Product Alert

Type of Notification: Product Safety Notification

FM Approvals has been notified by LumaSense Technologies GmbH of a potential defect due to porosities involving the FM USA & Canada Approved and ATEX/ IECEx certified E2T Pulsar 4 Advanced Infra-Red Pyrometers and E2T Pulsar 4 Infra-Red Pyrometers.

Subject: Pulsar 4 and Pulsar 4 Advanced hazardous area usage warning

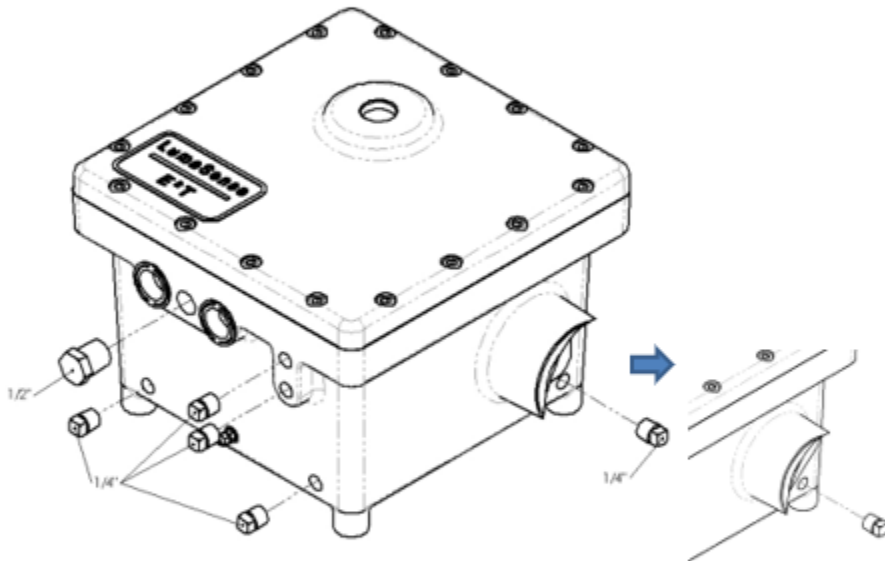
This notice is to advise the users of the Pulsar 4 and Pulsar 4 Advanced devices that it has been discovered that some of the enclosures have porosities in their casting which could reduce the strength of the enclosure in terms of explosion safety and may also allow water entering into the main electrical compartment if the water-cooling base is used.

Problem description: The investigation revealed that these porosities could have occurred where there is asymmetric pouring and uneven cooling during the casting process which cannot be visually observed during the casting process. This led to the potential cause of porosities in the bottom area of the enclosure. A new pouring concept was established and tested for symmetric pouring conditions and uniform cooling to prevent inclusions and porosities that could lead to leakages.

- Remove the existing 3/4 inch and 1/2 inch stopping plugs on the product and replace them with the ATEX/IECEX rated Ex db IIC Gb 3/4 inch NPT and ATEX/IECEX rated Ex db IIC Gb/ Class I Division I Groups A, B, C & D 1/2 inch stopping hexagon socket plugs supplied with this notice and by following the replacement instruction below.

Replacement Instructions: To ensure the certification of the internal Ex proof compartment, the indicated plugs as shown in the picture should be replaced as follows:

- The installation needs to be carried out by qualified Ex personnel
- No damage should occur to any thread or form during installation
- The threads need to be engaged wrench tight into the threaded hole
- A minimum of 5 threads engagement has to be maintained when tightened
- Conduct a visual check after replacing all stop plugs to ensure that no damage is on the plugs, threads or enclosure
